### APPEAL SUMMARY

<b>Appeal ID:</b> 20406	<b>Project Address:</b> 123 SE 13th Ave
<b>Hearing Date:</b> 5/15/19	<b>Appellant Name:</b> Joshua Scott
<b>Case No.:</b> B-016	<b>Appellant Phone:</b> 2067551290
<b>Appeal Type:</b> Building	<b>Plans Examiner/Inspector:</b> Natalie Didion
<b>Project Type:</b> commercial	<b>Stories:</b> 4 <b>Occupancy:</b> R-2 <b>Construction Type:</b> V-A
<b>Building/Business Name:</b>	<b>Fire Sprinklers:</b> Yes -
<b>Appeal Involves:</b> Erection of a new structure	<b>LUR or Permit Application No.:</b> 17-145908-CO
<b>Plan Submitted Option:</b> pdf [File 1] [File 2] [File 3] [File 4]	<b>Proposed use:</b> Multifamily Residential

**One hour fire rated protection of columns fully contained within fire rated wall membrane per 2018 IBC:**  
**Hold for additional information.**

Project: ANKENY

**1** Steel column in 1 HR wall (Typical)

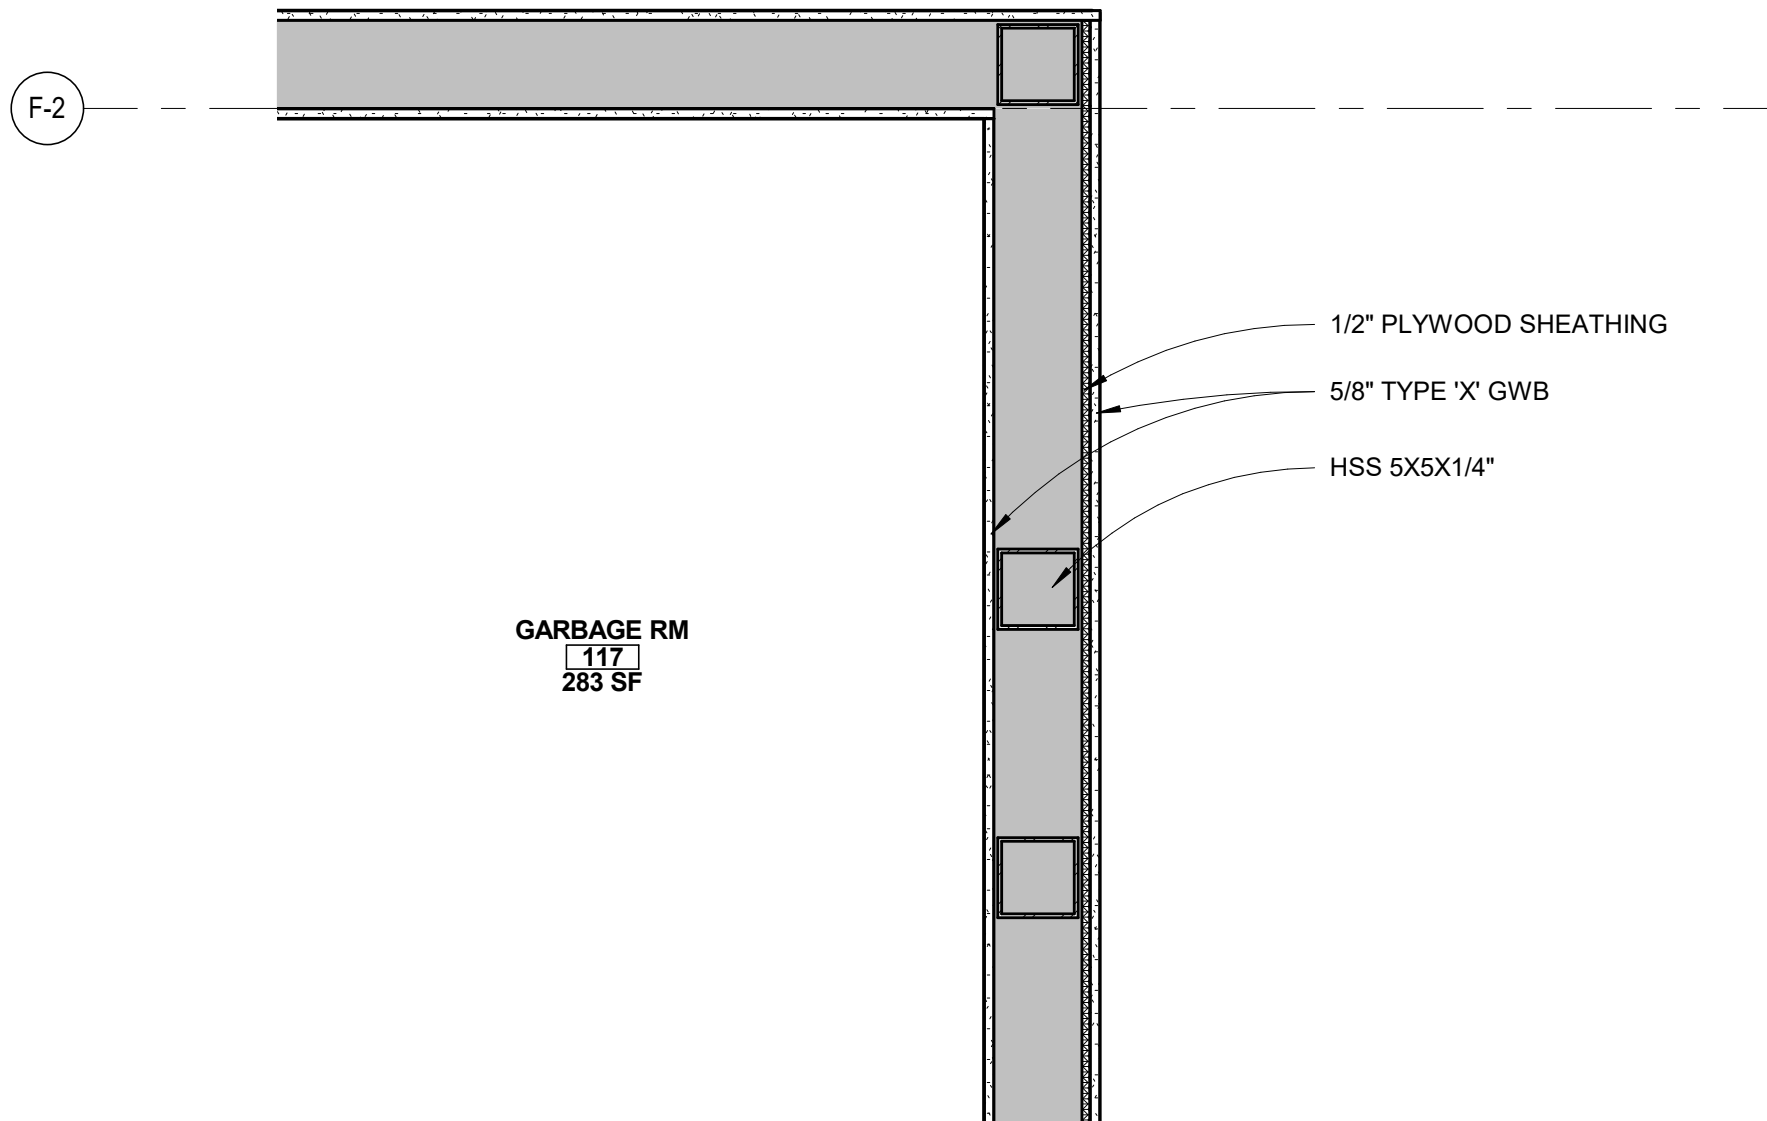
**Proposed Design** Where columns are located within fire-rated wall cavities the membrane protection of the wall provides the fire rated protection for the columns within. Therefore, columns within wall cavities are not protected (encapsulated) with fire rated construction on all four sides. Columns that occur outside of walls to be protected on all four sides with fire rated construction. The specific columns for with this appeal applies are clouded and noted on the attached framing and floor plans.

**Reason for alternative** The 2018 IBC has been updated to add an exception for "columns that meet limitations of Section 704.4.1." Section 704.4.1 now includes columns. "Studs, columns, and boundary elements that integral elements in walls of light-frame construction and are located entirely between the top and bottom plates or tracks shall be permitted to have required fire-resistance rating provided by the membrane protection provided for the wall."

Where columns are located within fire-rated wall cavities the membrane protection of the wall provides the fire rated protection for the columns within. Therefore, columns within wall cavities are not protected (encapsulated) with fire rated construction on all four sides. Columns that occur outside of walls to be protected on all four sides with fire rated construction.
